REQUEST FOR ADDITIONAL INFORMATION - HCGS PUAR
HOPE CREEK GENERATING STATION
DOCKET NO. 50-354

HOPE CREEK GENERATING STATION

PLANT UNIQUE ANALYSIS REPORT

ADDITIONAL INFORMATION ON HYDRODYNAMIC LOADS FOR NRC REVIEW

Figure 8-3

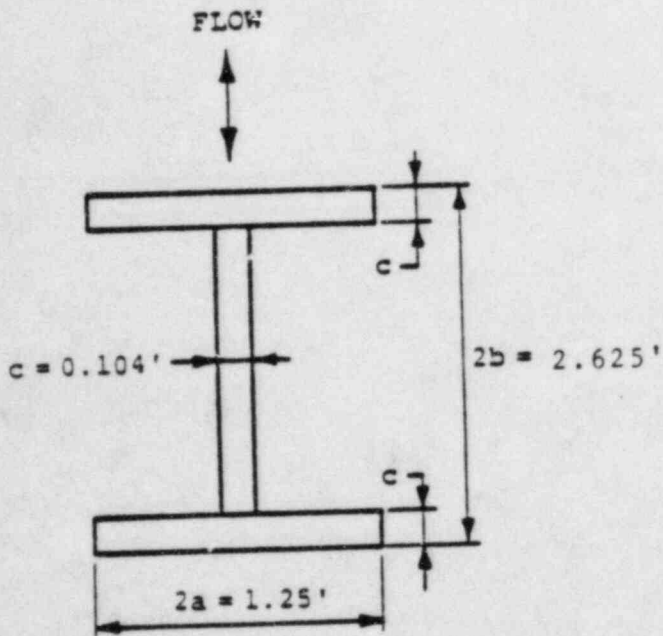
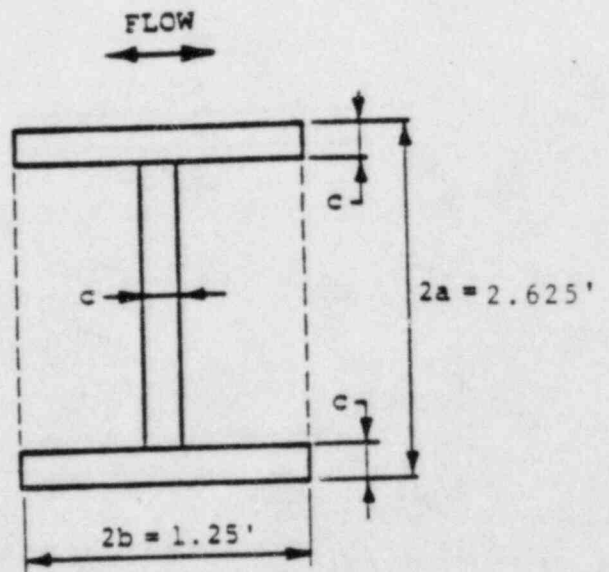
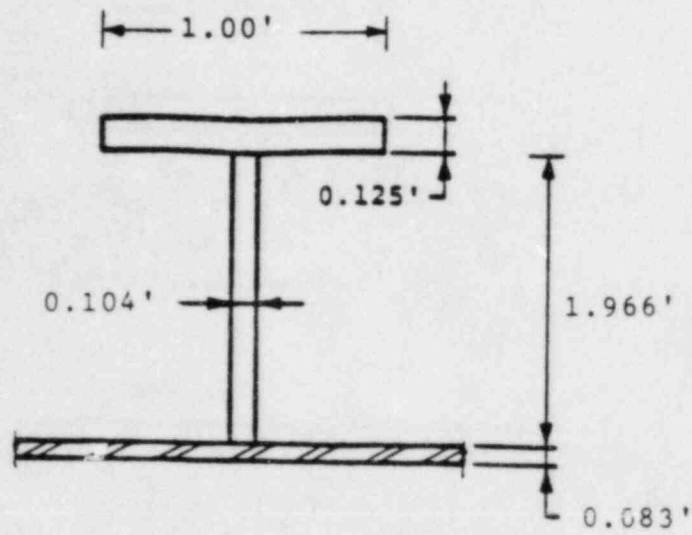
ITEM 8: The Hope Creek PUAR states that acceleration drag volumes for structures with sharp corners, such as I-beams, are computed using Table 1-4.1-1 when submerged structure drag loads due to pool swell, CO, chugging and SRV actuation are calculated. Since direct use of Table 1-4.1-1 is not possible for the ring girders, the specific formulas and acceleration volume values used for the ring girders are needed. Provide details of the acceleration volume calculation for drag loads in direction normal to the flange, web and stiffeners, respectively, for both the mitered joint and midcylinder ring beams. Provide final values of acceleration drag volumes in each direction for two or three segments of each beam.

For the purpose of calculating submerged structure loads on the ring girders, midcylinder and miter ring girders were divided into 11 and 14 segments as shown in Figures 8-1 and 8-2. The geometry of the ring girders and the models used to calculate the acceleration drag volumes for the in-plane and out-of-plane (normal to web) directions for the midcylinder and miter ring girders are shown in Figures 8-3 and 8-4.

For the in-plane direction (normal to the flange) the ring girders were modeled as I-beams, and the formula used to develop the acceleration volumes (Table 1-4.1-1 in PUAR) is:

<u>Parameter</u>	<u>Midcylinder Value (Segments 1 through 5 and 7 through 11)</u>	<u>Miter Value (Segments 1 through 6 and 9 through 14)</u>
a (ft)	0.625	0.5
b (ft)	1.312	1.045
c (ft)	0.104	0.125
L (ft)	3.830	2.983
A_w	2.0	2.0
V (ft ³)	23.75	12.76

The dimensions a, b, and c are shown in Figures 8-3 and 8-4. The distance L is the segment length; A_w is the factor to account for wall interference effects.

$$V = [1.36 \pi a^2 + (2b-c)2c + 2ac] L A_w$$

<u>Parameter</u>	<u>Midcylinder Value (Segments 1 through 5 and 7 through 11)</u>	<u>Miter Value (Segments 1 through 6 and 9 through 14)</u>
a (ft)	1.312	1.045
b (ft)	0.625	0.5
c (ft)	0.104	0.125
L (ft)	3.830	2.983
A _w	2.0	2.0
V (ft ³)	60.30	30.72

Figure 10-1

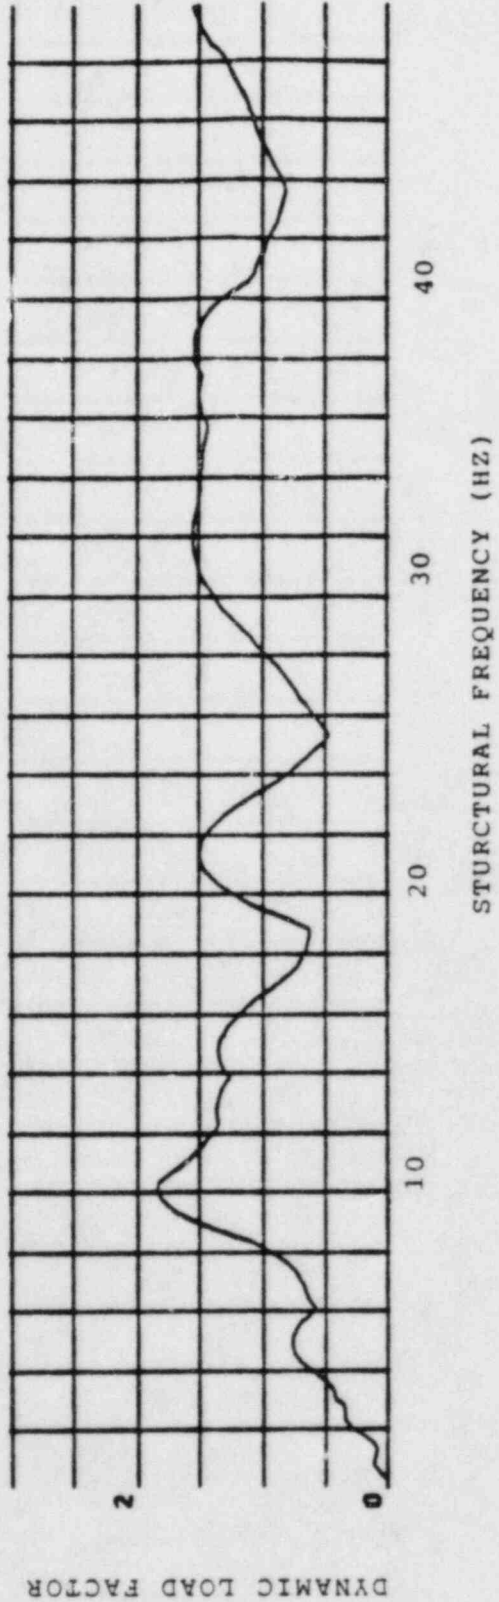
ITEM 10: Section 1-4.2.4 of the PUAR states that dynamic load factors for SRV bubble-induced drag loads in Hope Creek are derived from Monticello in-plant SRV test data. Describe in detail how these factors are derived and applied to Hope Creek, giving numerical values of the factors for major structural components. Describe how extrapolation from test to design conditions is made and why Monticello data provides a conservative basis for Hope Creek.

As permitted by NUREG-0661 (Section 3.10.2.13), Dynamic Load Factors (DLF) for SRV bubble drag submerged structure loads were calculated using SRV discharge bubble pressure time histories measured during the Monticello SRV in-plant test. These bubble pressure time histories were applied to a damped single degree-of-freedom model. Attached Figure 10-1 is a typical DLF versus structural frequency plot for these pressure time histories.

A bounding DLF of 2.5 was generated from Monticello SRV in-plant test data. The same bounding DLF was used for Hope Creek. Test data from other plants like Dresden 2 and Duane Arnold produced DLF values which were also bounded by 2.5. Thus, Monticello test data was considered to be a conservative basis for Hope Creek.

Submerged structures were analyzed using the bounding DLF of 2.5 times the maximum calculated design bubble pressure loads. For structures whose natural frequency was outside the range of SRV bubble drag loads (such as ring girders out-of-plane direction, and vent header support columns), a DLF of 2.0 was conservatively used. The DLF values at resonant condition were developed from the measured pressure time histories at test conditions and were applied to the design basis event conditions as permitted by NUREG-0661, Section 3.10.2.13.

Figure 11-1
RECTANGULAR CELL MODELING FOR PLANTS WITH 80 DCS
C.O. AND CHUGGING (CELL A)

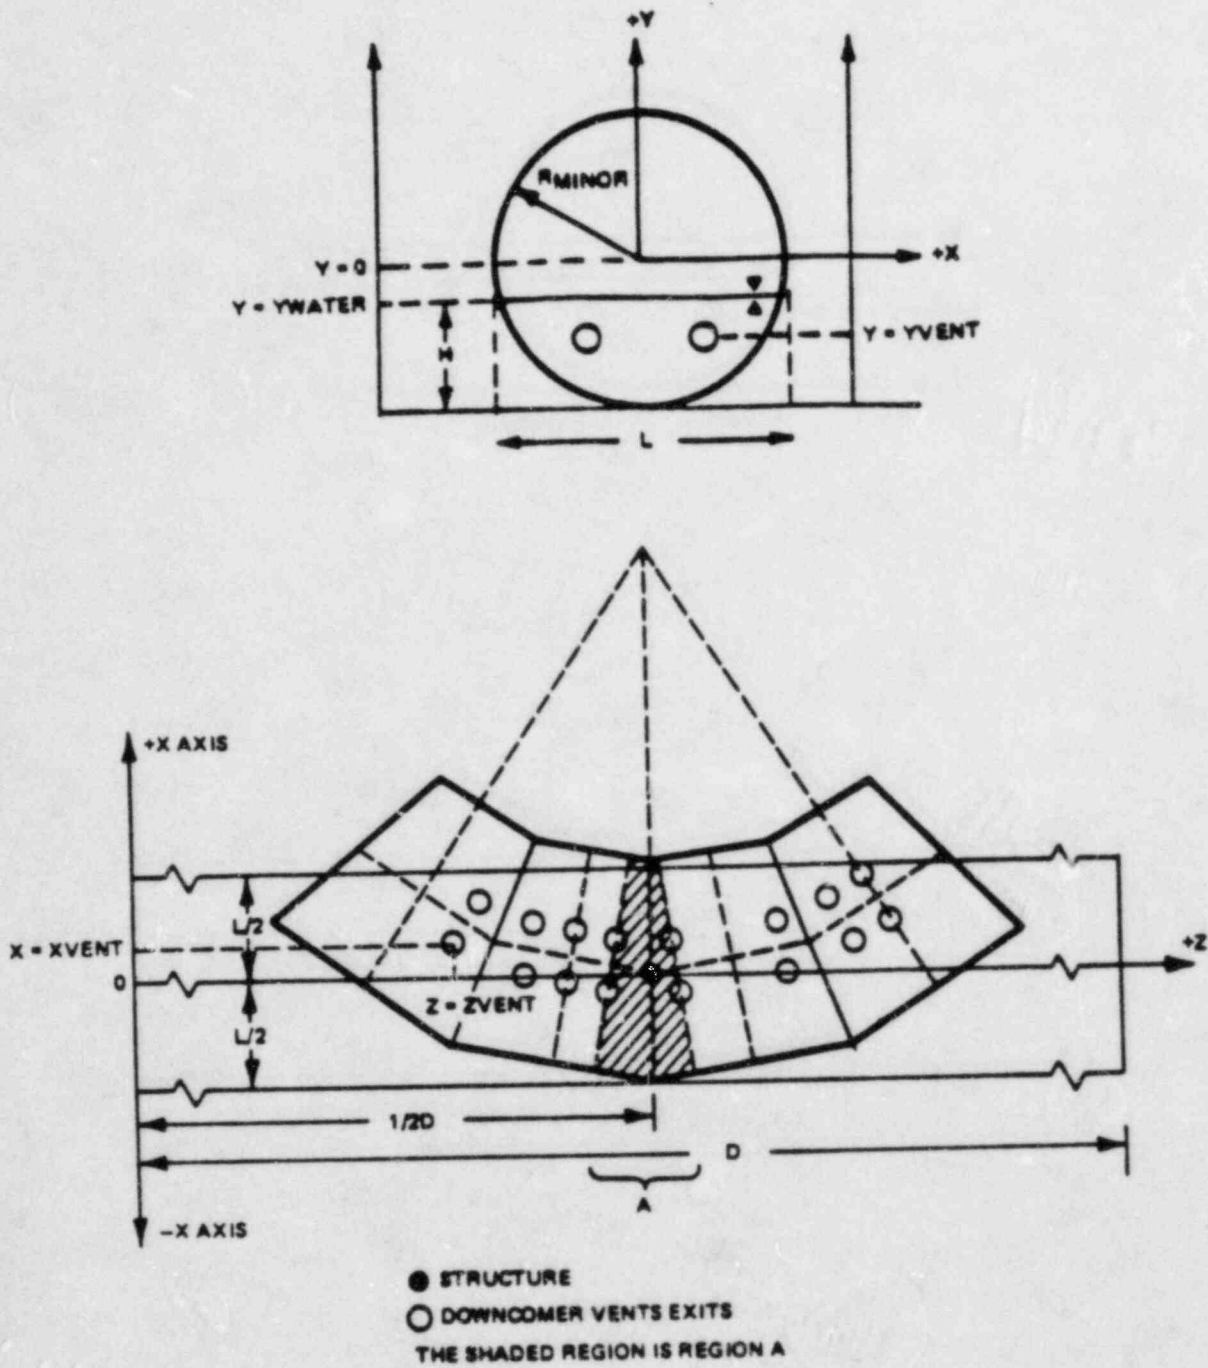
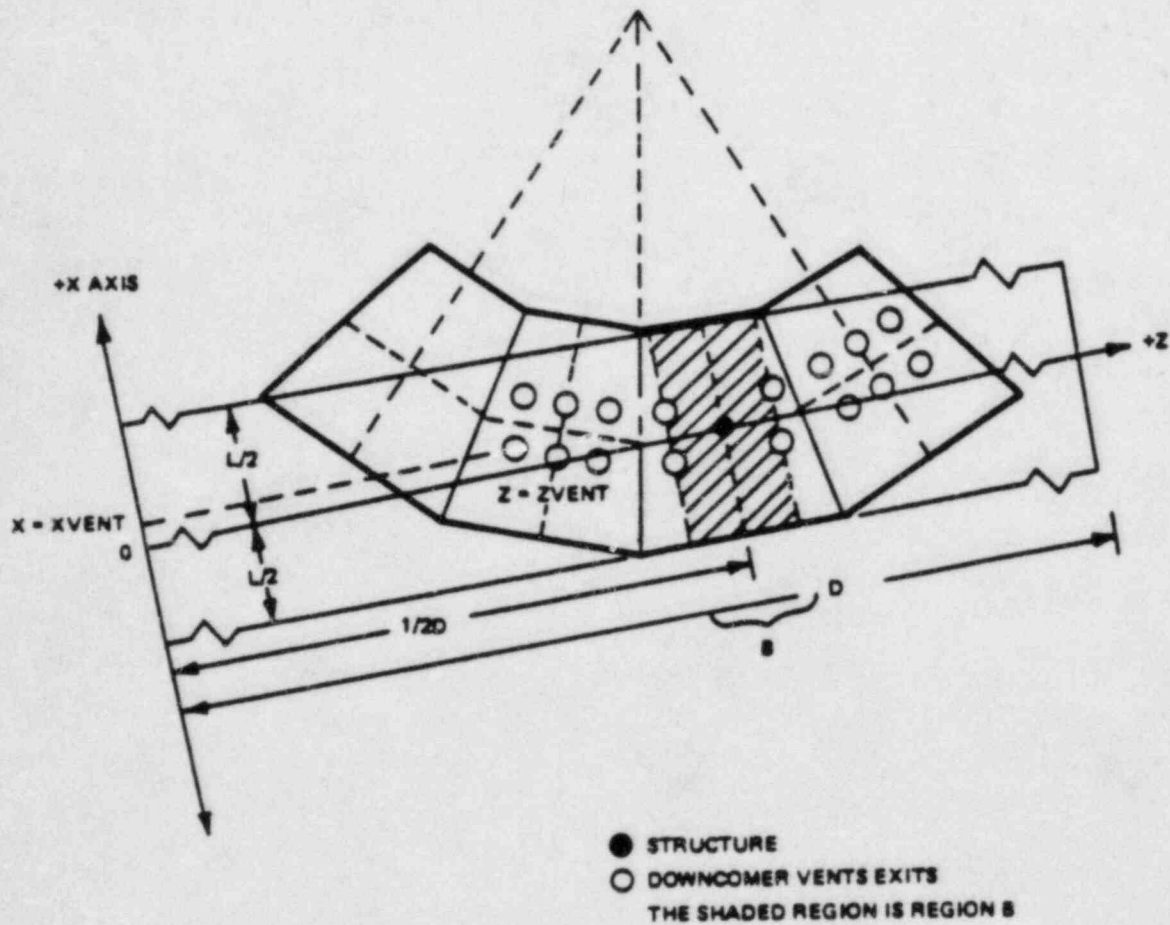
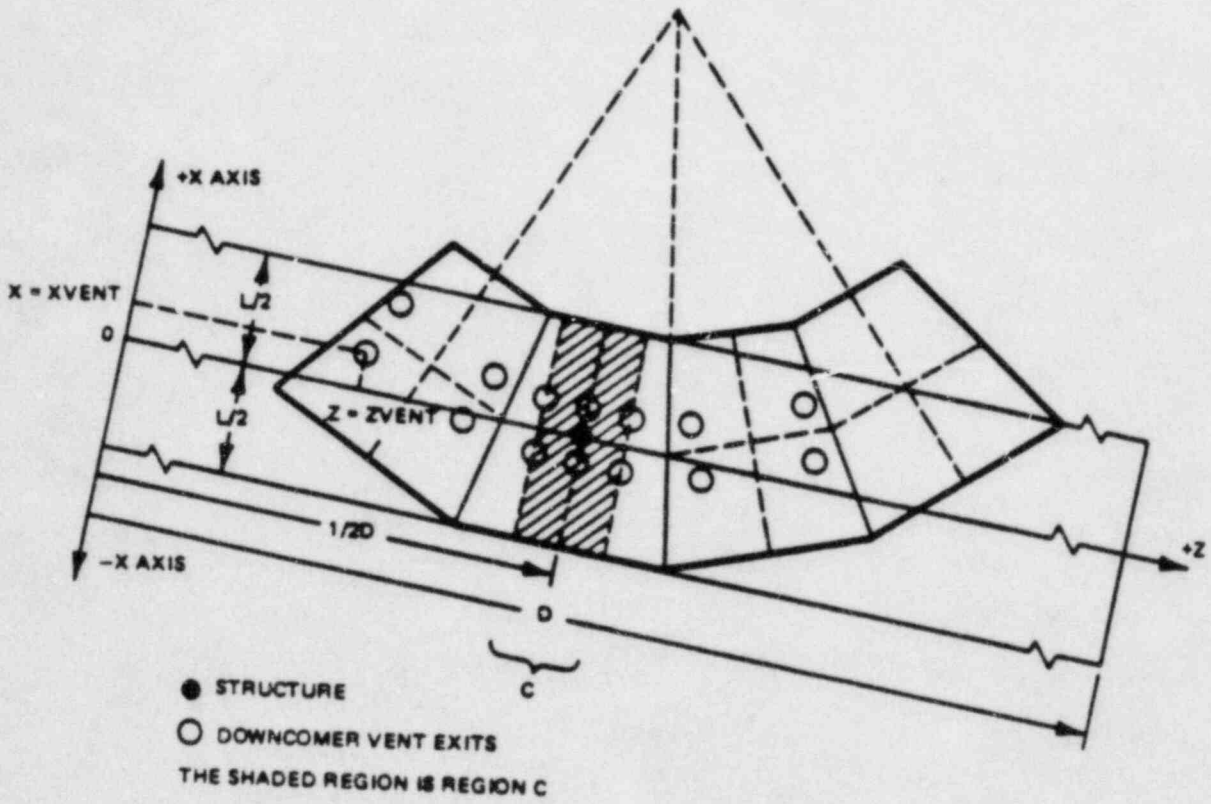
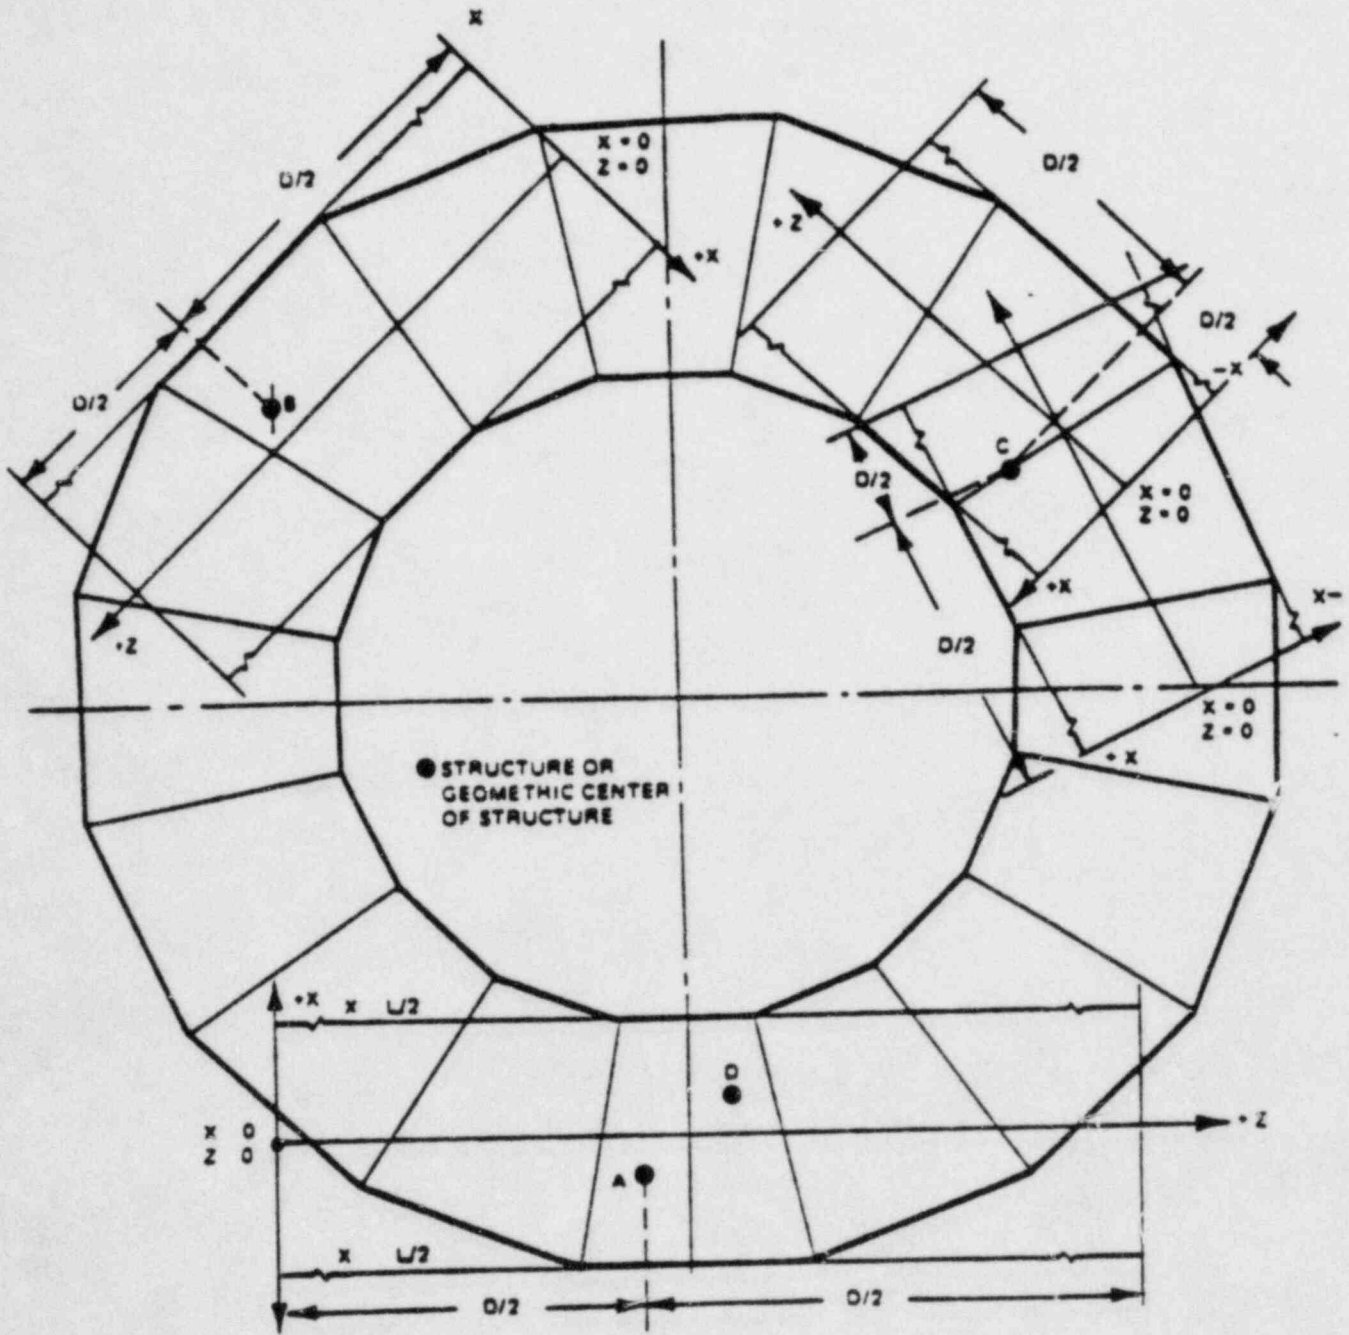
ITEM 11: Is the rectangular bay model described in Table 1-4.1-2 of the PUAR used for LOCA bubble drag loads also used for CO, chugging and SRV loads on submerged structures? If yes, justify the use of this model for structures near the bay boundary which undergo asymmetric loading conditions. If a different model is used, give details.

The rectangular bay model for CO, chugging and SRV loads on submerged structures is similar to that used for LOCA bubble drag loads. As required in Appendix A of NUREG-0661, Model E in NEDE-21983-P is used for the method of images simulation of the torus cross-section for LOCA air bubble, CO, chugging and SRV analyses. The length of the bay model for LOCA air bubble analysis varies from one and a half to two bays for Hope Creek, and structures may be close to the bay boundary.

However, for the CO, chugging and SRV analyses, structures are always placed at or very near the center of the rectangular bay model ($1/2 D$) as shown in Figures 11-1, 11-2, 11-3, and 11-4. From these figures it can be seen that the torus is unwrapped to a length D which is equal to the torus circumference ($D = 2\pi R_{\text{major}}$, $D_{\text{Hope Creek}} = 354 \text{ ft}$). Hence, structures are never near the bay boundary and asymmetric loading conditions, i.e., sources acting in one bay only, are readily accommodated.
